Burlington Development Review Board

Development Review Board

Wednesday, March 25, 2026, 5:00 PM

To: Development Review Board
From: Mary O'Neil, AICP, Principal Planner
Date: March 25, 2026
RE: ZP-26-54; 49 Henderson Terrace

SHEET NO: S100

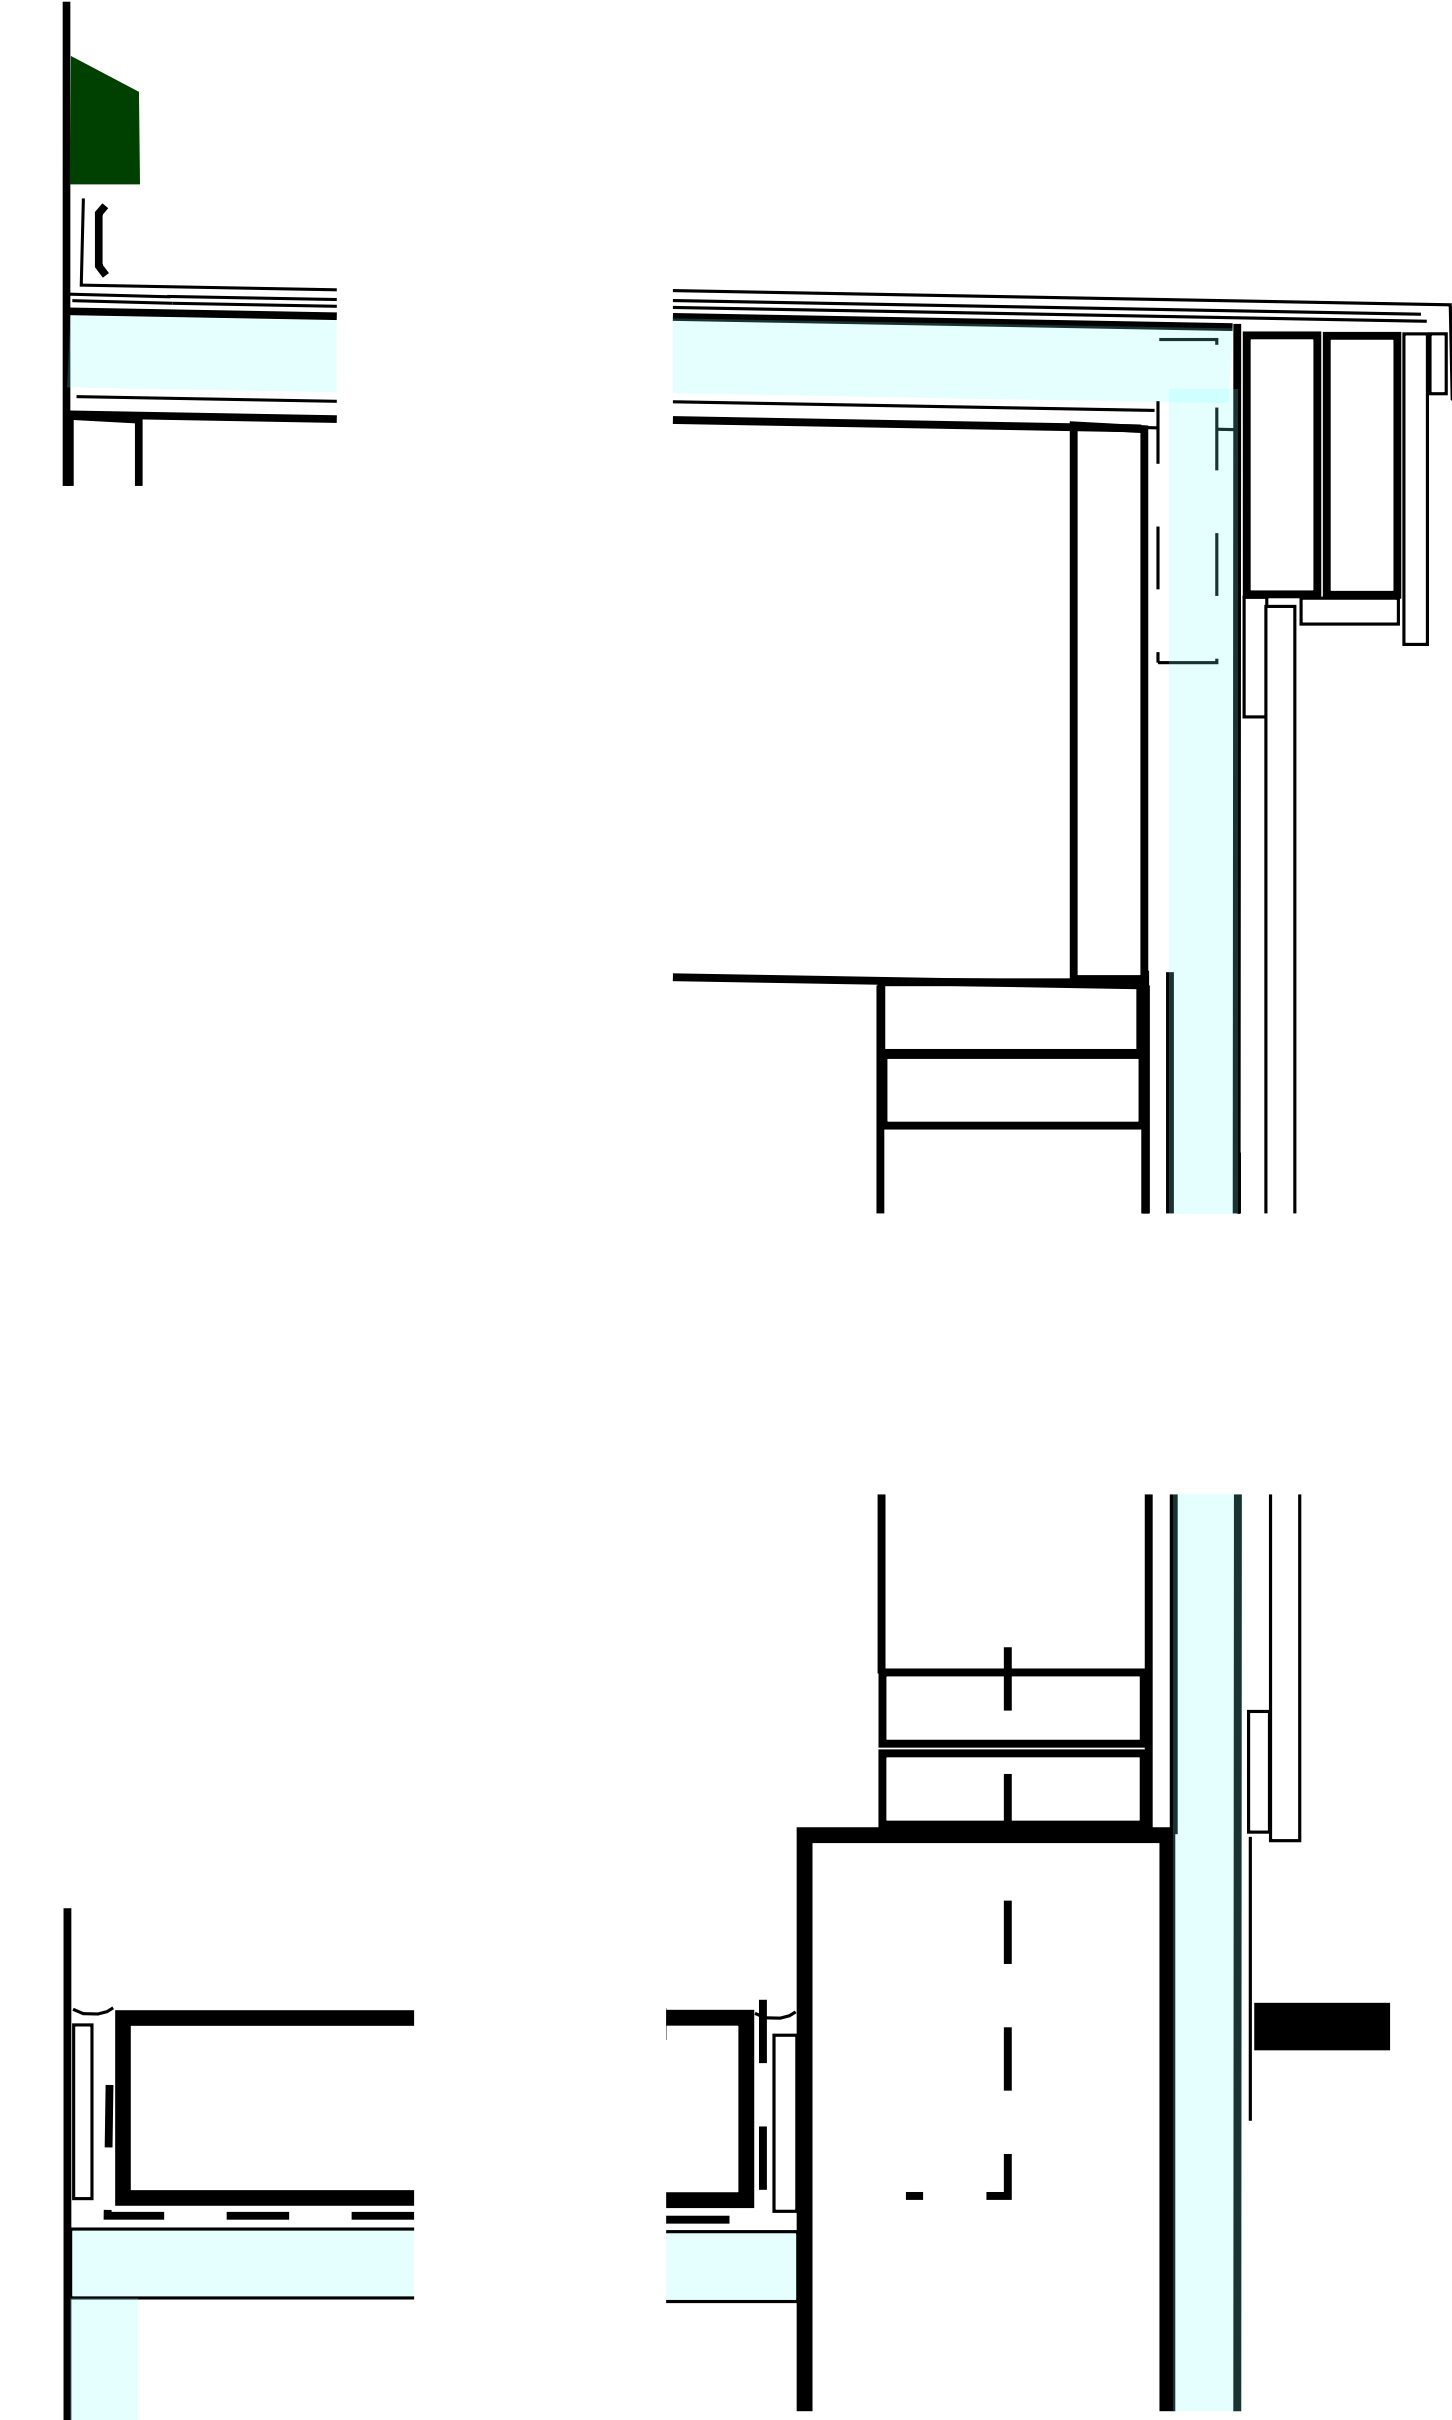
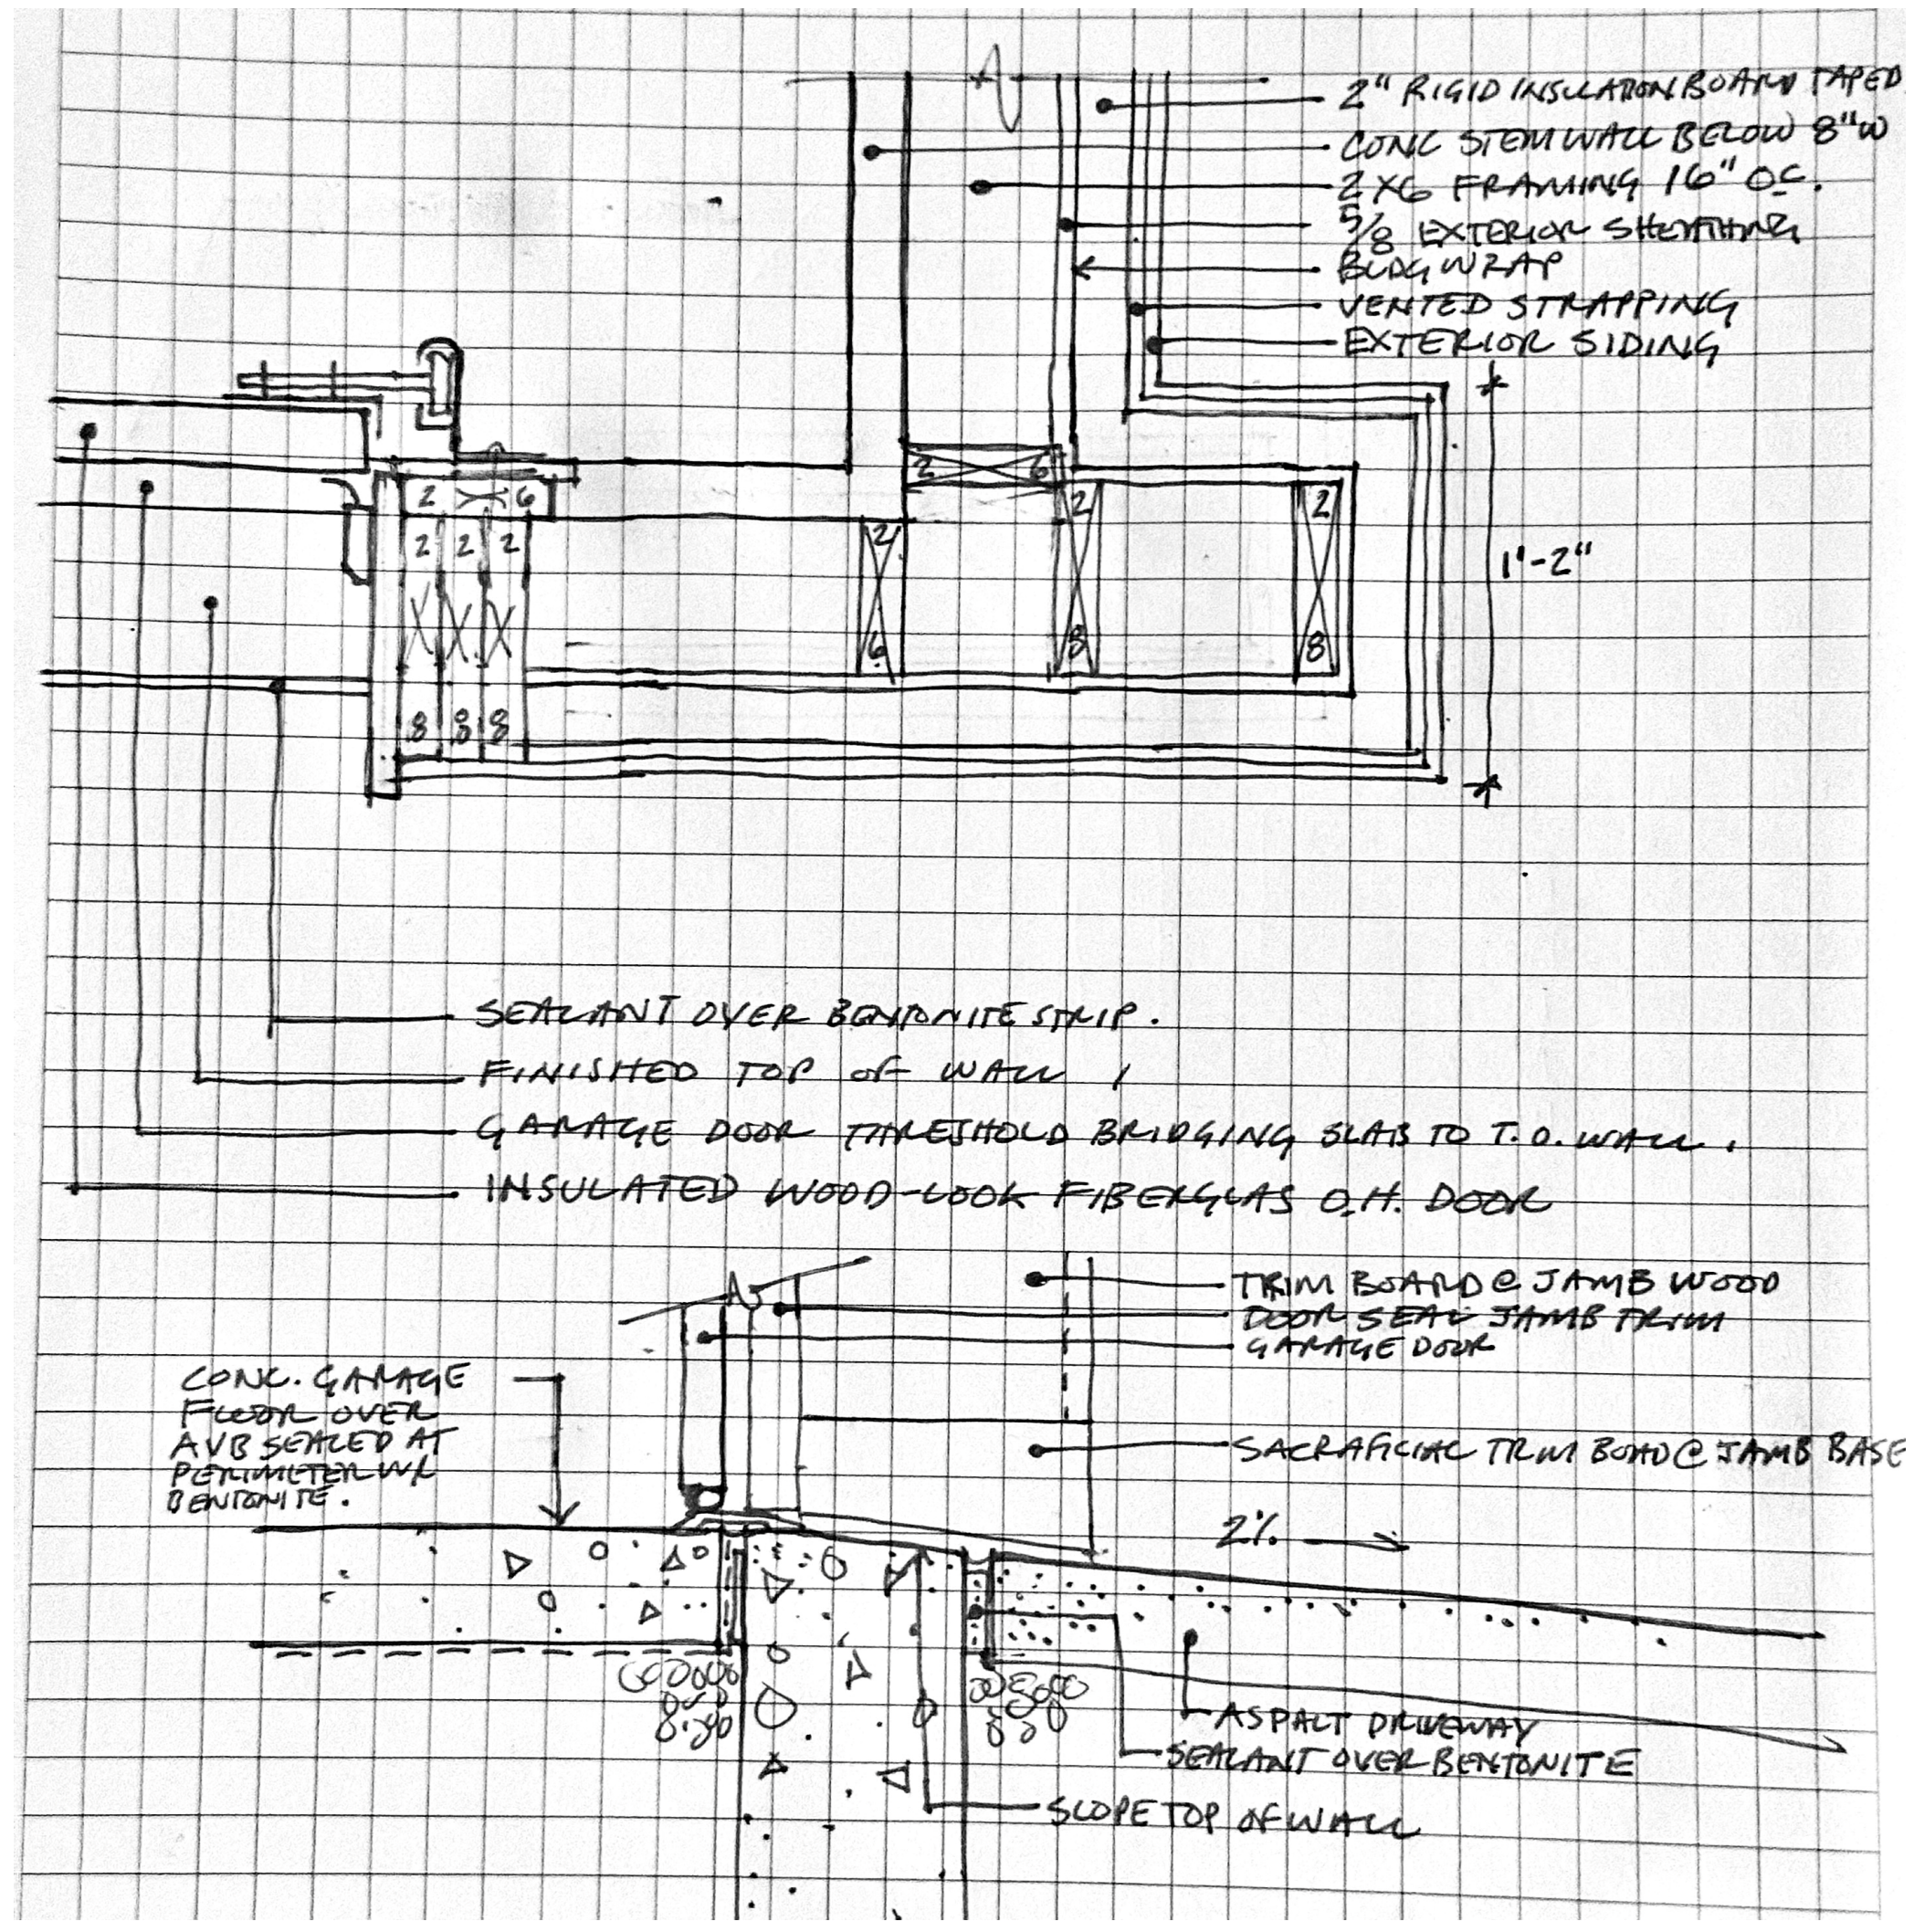
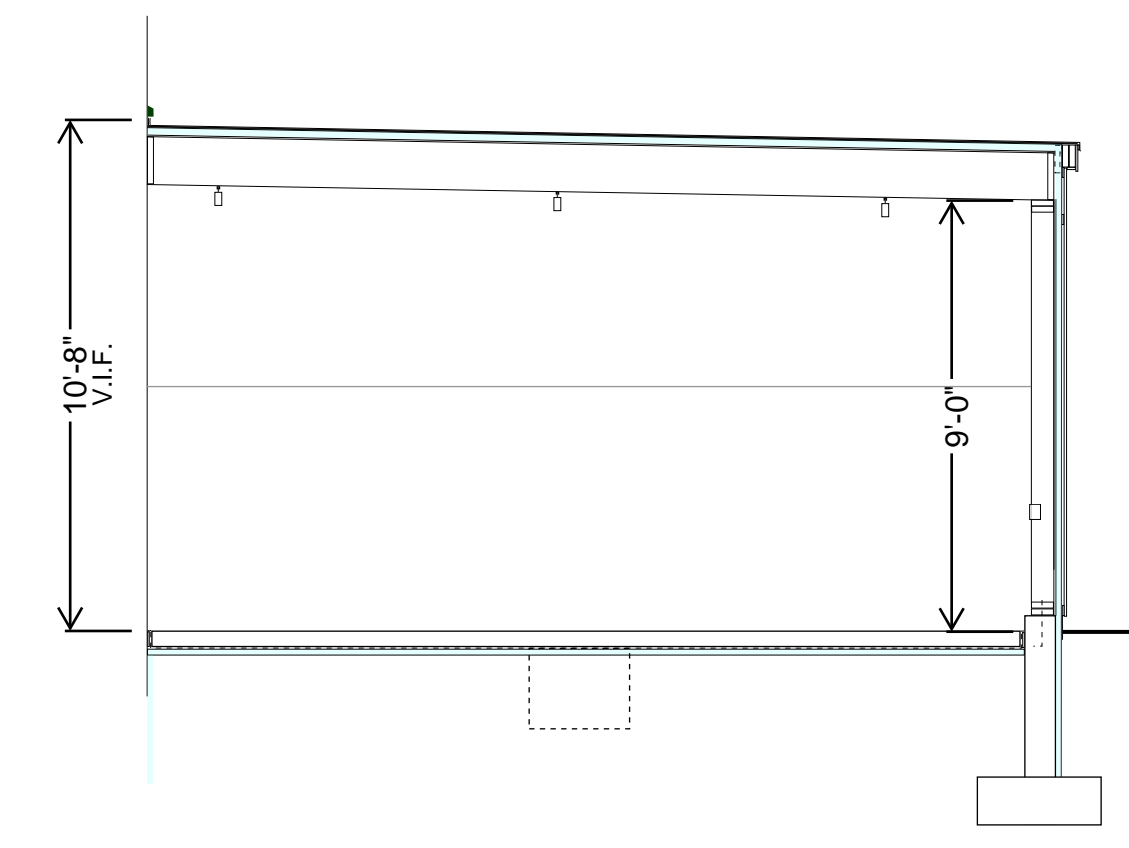
Part of the garage foundation includes a structural retaining wall to support the existing front porch. Reference is made to plans S100. **Affirmative finding.**
